TOWN OF ORLEANS, MA
WASTEWATER TREATMENT FACILITY AND EFFLUENT DISPOSAL

CONTRACT NO. 2019-01
SRF NO. 4486

JANUARY 2020

COVER SHEET AND LOCATION PLAN

15 D-103

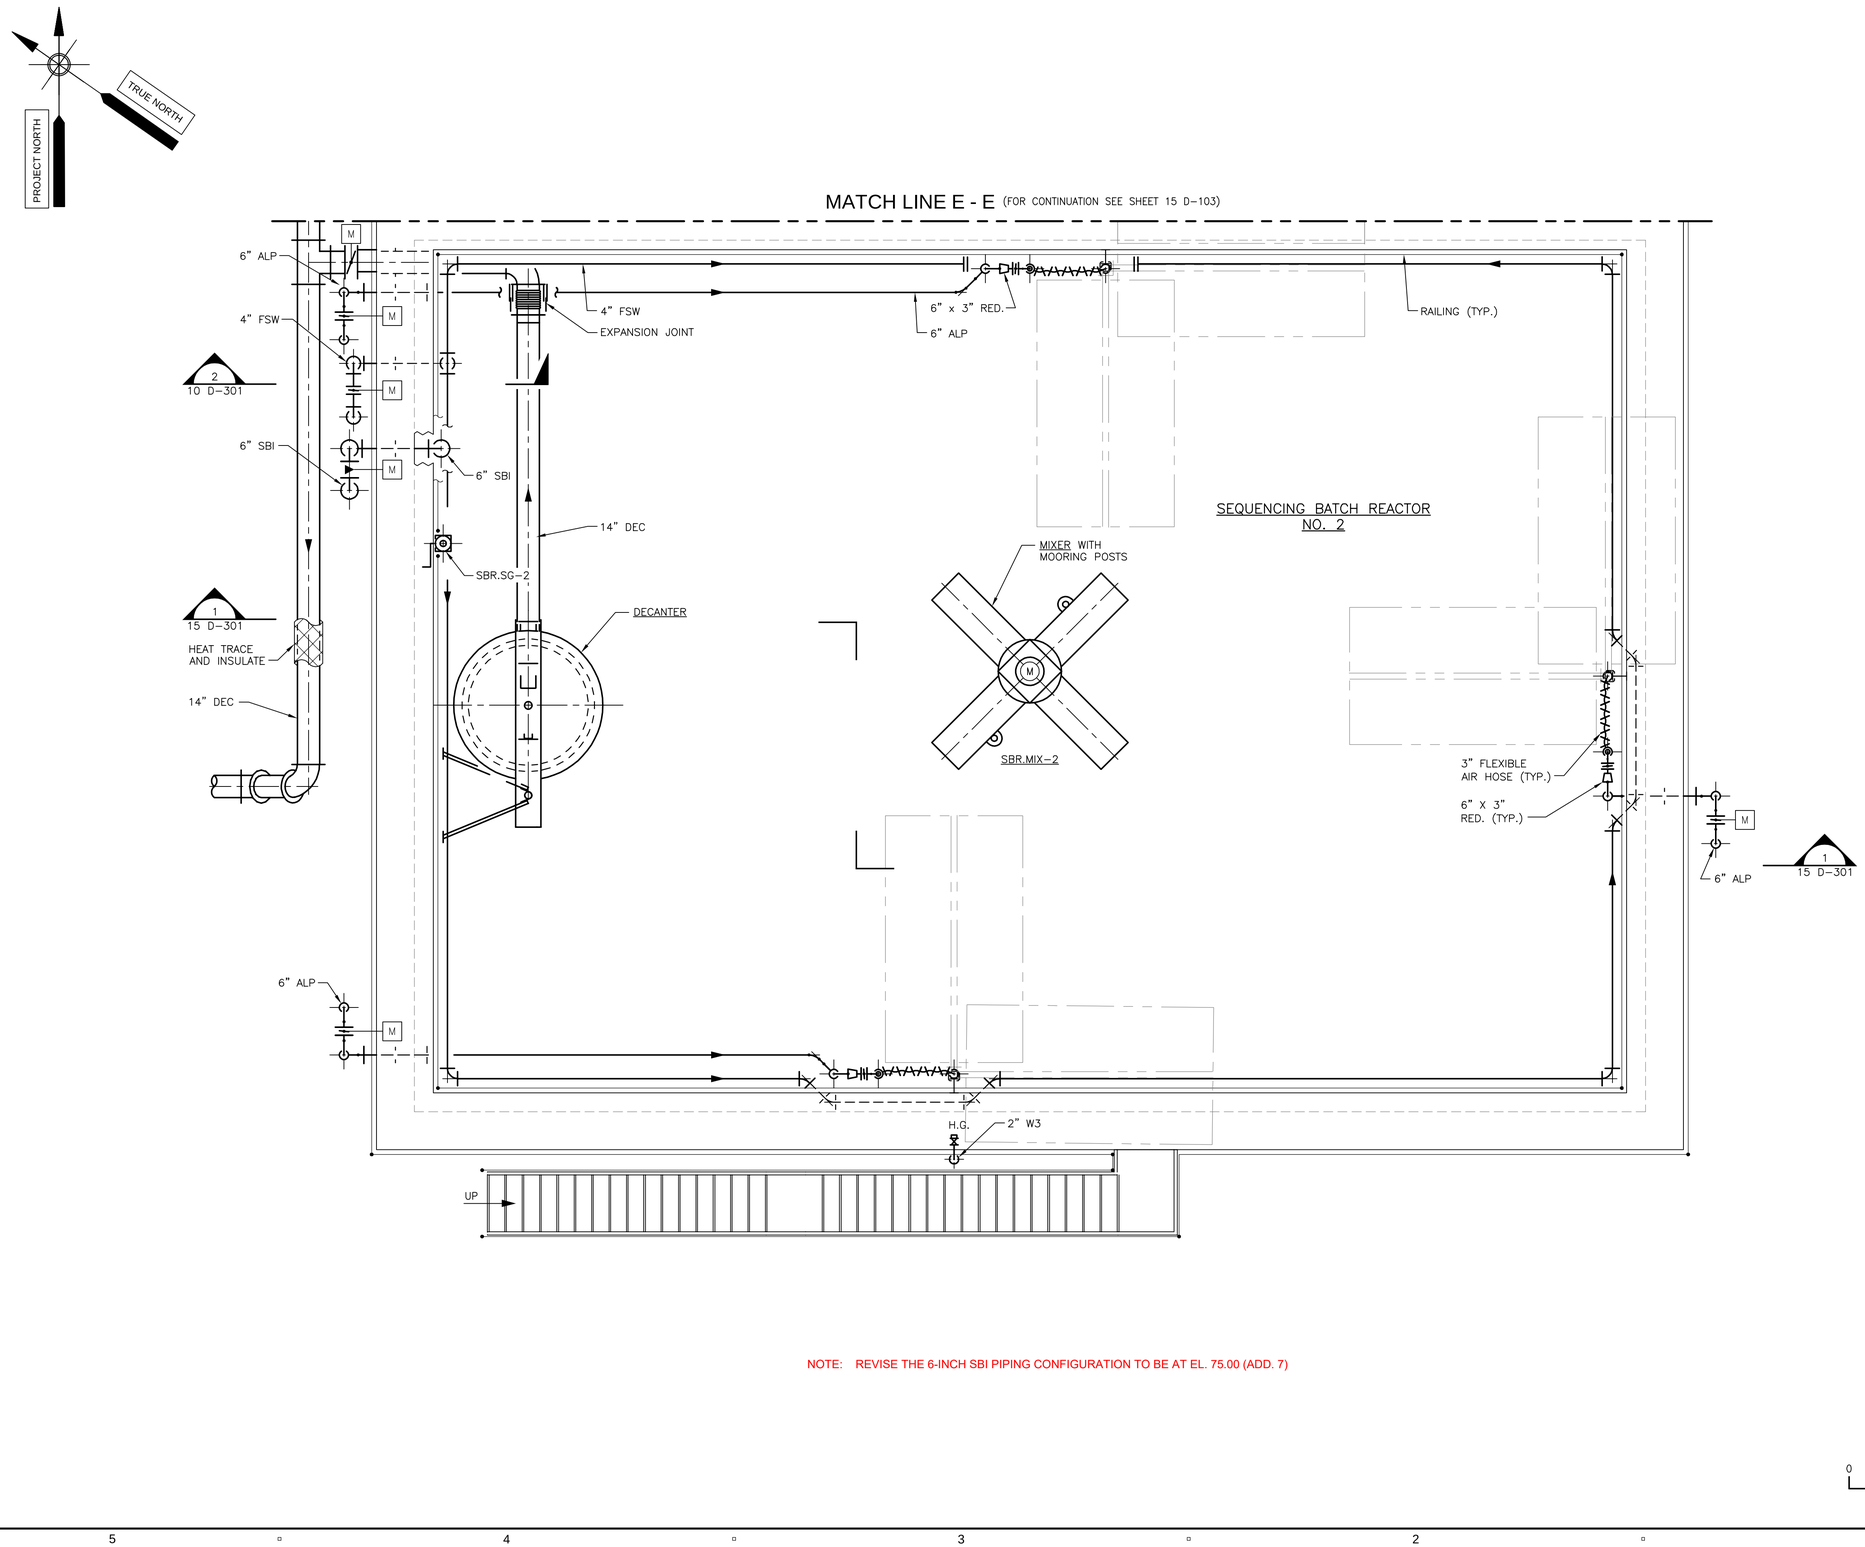
NOTE: REVISE THE 6-INCH SBI PIPING CONFIGURATION TO BE AT EL. 75.00 (ADD. 7)

10 DI-602

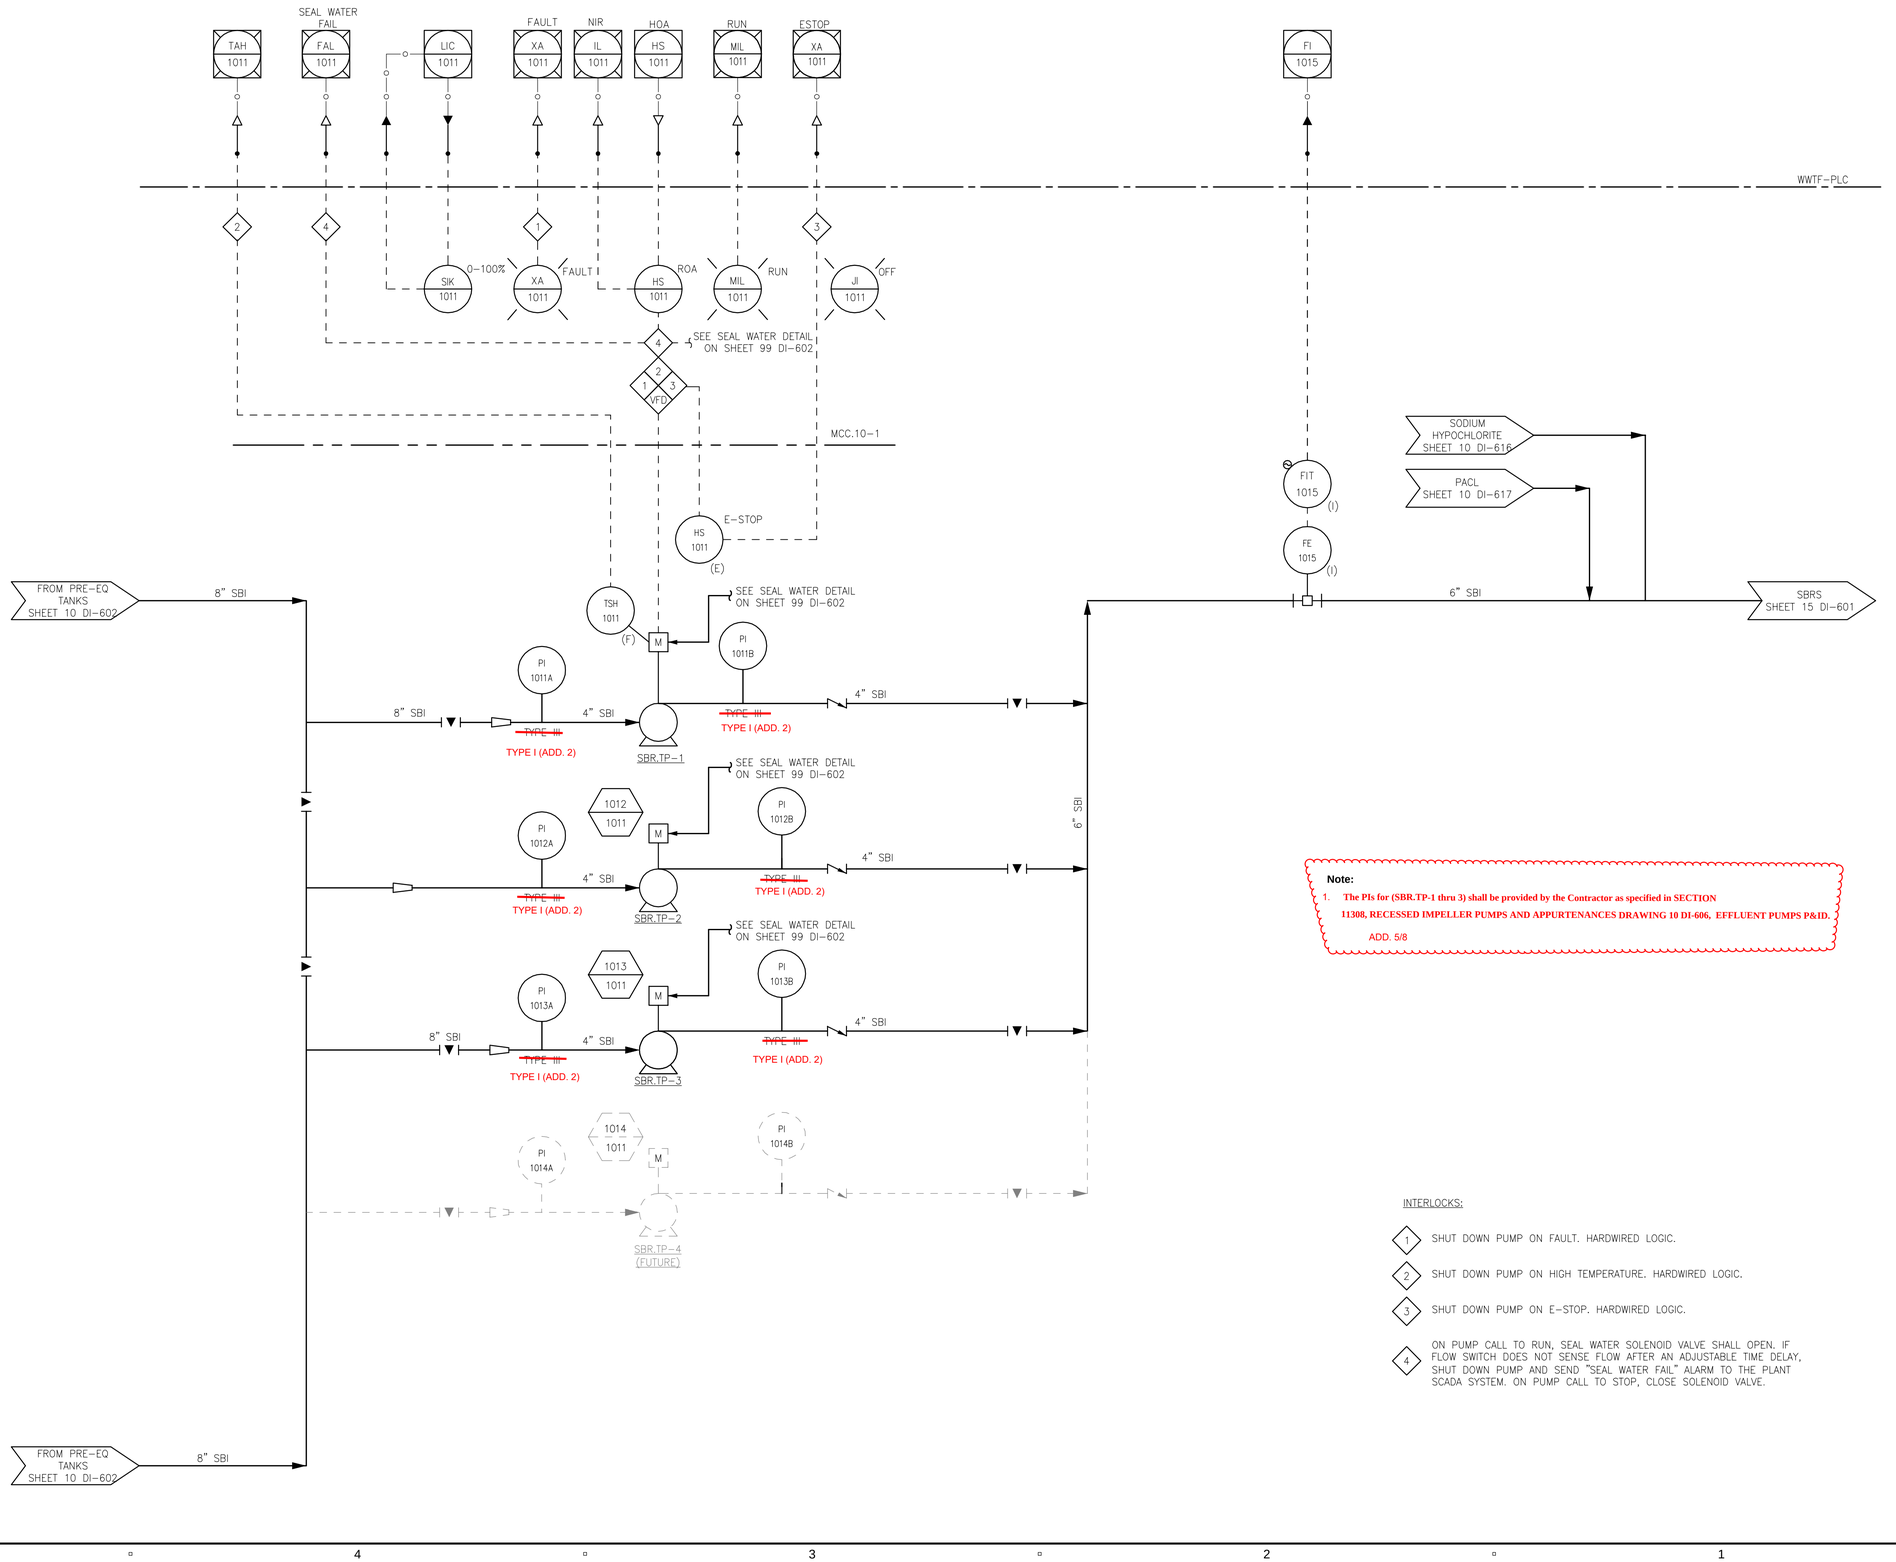
1. **The PIs for (SBR.TP-1 thru 3) shall be provided by the Contractor as specified in SECTION 11308, RECESSED IMPELLER PUMPS AND APPURTENANCES DRAWING 10 DI-606, EFFLUENT PUMPS P&ID.**
